Review of Lighthouse Point Environmental Impact Assessment

Woods Hole Group reviewed the Environmental Impact Assessment – Lighthouse Point, Eleuthera, The Bahamas (the EIA) prepared March 2021 for DCL Island Development, Ltd. Our review of the EIA for the proposed development of a cruise port and entertainment destination at Lighthouse Point (the Project) focused on coastal processes and engineering, coastal hazards related to climate change, water quality, and project-related greenhouse gas emissions modeling. This letter summarizes Woods Hole Group’s comments on the EIA with respect to these subject areas. These comments were developed based on our experience in these subject areas, professional judgement, knowledge of the state of the practice, and expectations for the development of a complete environmental impact assessment.

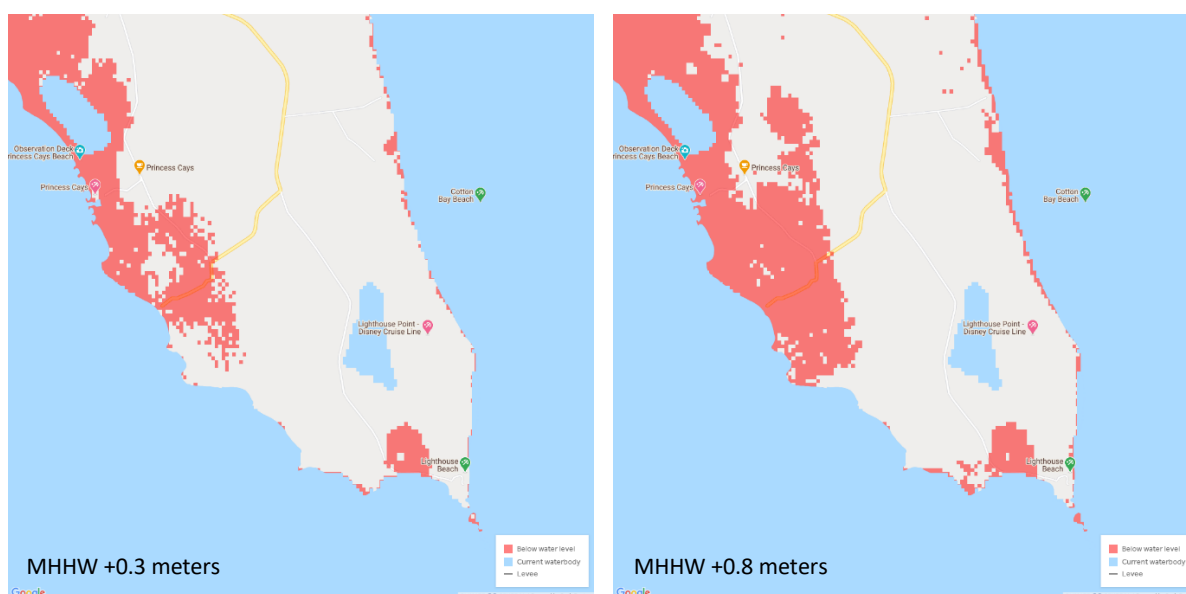
Since the project has a stated design life of 50 years, the planning horizon for assessment should be approximately 2070 (2080 if construction is anticipated through 2030). The EIA uses a sea level rise projection of 1.0 foot relative to 2017 levels over the 50-year design life of the Project. Although this projection aligns with the projections presented in the 2014 Bahamas Second National Communication to the UNFCCC, it is not consistent with the current state of the practice in sea level rise planning.

Current best practice is to develop **local sea level rise projections using the "K14" (Kopp et al., 2014) approach which provides conditional probability distributions for different greenhouse gas emissions trajectories** and enables integration of these probabilistic projection into different scenarios to support asset planning and decision-making. This is the approach applied in the Fourth National Climate Assessment (Sweet et al., 2017) for the United States, adopted by multiple states for climate planning (including Massachusetts, California and New Jersey), and also used by Climate Central to develop projections for the Caribbean (Strauss and Kulp, 2018).

For example, the Climate Central probabilistic sea-level projections for Settlement Point, Bahamas are 0.28 to 0.32 meters above the baseline (year 2000 mean sea level) for the range of 2050 emission scenarios and 0.54 to 0.83 meters above the baseline for the range of 2100 emission scenarios. Thus, the 1.0 foot relative to 2017 used in the EIA is likely on the low end of possible sea level rise projections over the stated design life even when not accounting for contributions from ice sheet melt. The EIA should **present the range of potential sea level rise scenarios over the project design life overlaid with the development plan** in order to visualize the potential impacts. For instance, the following figures show areas of inundation 0.3 meters and 0.8 meters above the present local mean higher high water (MHHW). Review of these maps suggests that the proposed South Family Beach area south of Shad Pond and White Pond is particularly vulnerable to future tidal inundation over the stated life of the development.

For regional context, the **Southeast Florida Regional Climate Change Compact** (the Compact) released updated **Unified Sea Level Rise Projections** in 2019. The Compact states that “by 2070, sea level is projected to rise 21 to 54 inches above 2000 mean sea level” (MSL) and recommends that **projects with a planning horizon up to 2070 plan for sea level rise between the IPCC Median and NOAA Intermediate High scenarios (21 to 40 inches or ~0.5 to ~1.0 meter above 2000 MSL).**

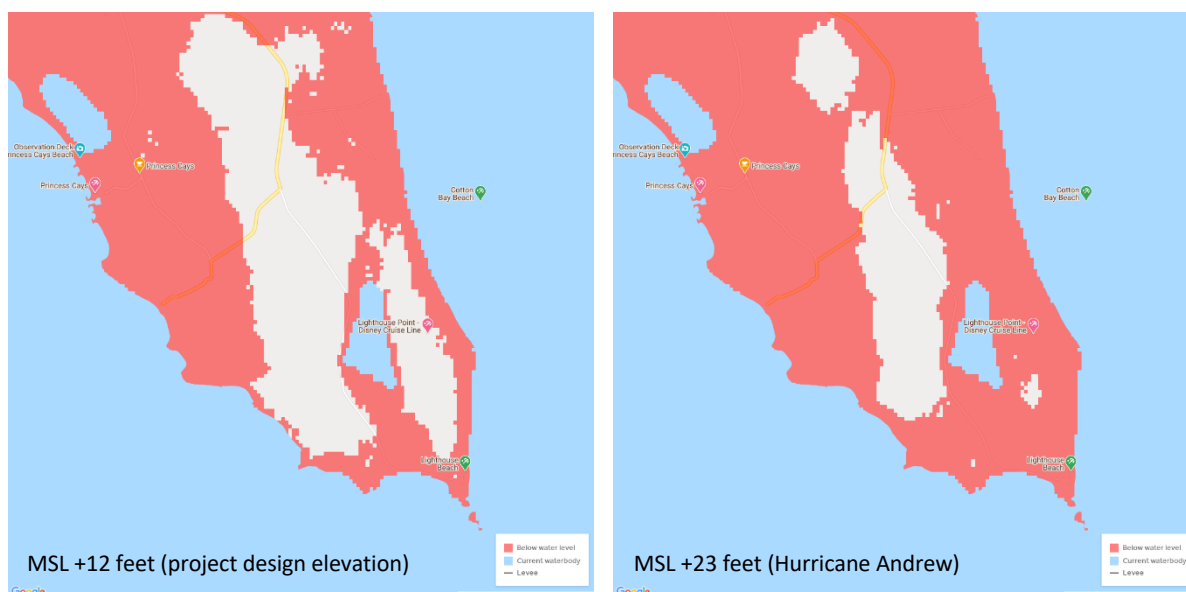
The EIA states that the Project will be designed to “withstand any impacts due to climate change” but specifies only that structures will be elevated at or above elevation 12 ft MSL. According to the project site tidal datums reported in the EIA, 12 ft MSL correlates to approximately 10.5 ft above MHHW. This vulnerable area should be overlaid with project development plans to determine the vulnerability of project elements, and the return period of such a storm event should be stated in order to assess risk. Initial mapping suggests that, **contrary to the EIA’s statement regarding locating development above vulnerable areas, project related development is proposed within this vulnerable area at or below 12 ft MSL**, as shown below.

The stated design flood elevation of 12 ft MSL is also lower than stated historical storm surge levels. A complete assessment of storm surge vulnerability would include, at a minimum, a map of the inundation from the surge associated with the storm of record or the results of NOAA Sea, Lake and Overland Surges from Hurricanes (SLOSH) model results for the area. **Based on the storm surge reported in the EIA from Hurricane Andrew (1992), a 23 ft storm surge at Lighthouse Point would overwhelm the project area** as shown below. Careful consideration of storm-related vulnerabilities is critical to making planning and design decisions in areas that are exposed to hurricanes.

Since there is present risk of flooding and damage, which will be accentuated in the future with climate change, the impacts due to climate change should be estimated for the stated design flood elevation for the Project. We recommend **appropriate design flood elevations for roadways, buildings and infrastructure be developed based on a review of the storm of record as well as an assessment of regional sea level rise, probabilistic extreme storm water levels, and extreme wave conditions**. It was noted that extreme wave conditions were not quantified in the EIA. A review or study of expected extreme wave conditions is needed to ensure resiliency measures and structures will be designed to withstand wave forcing (in addition to wind and storm surge levels).
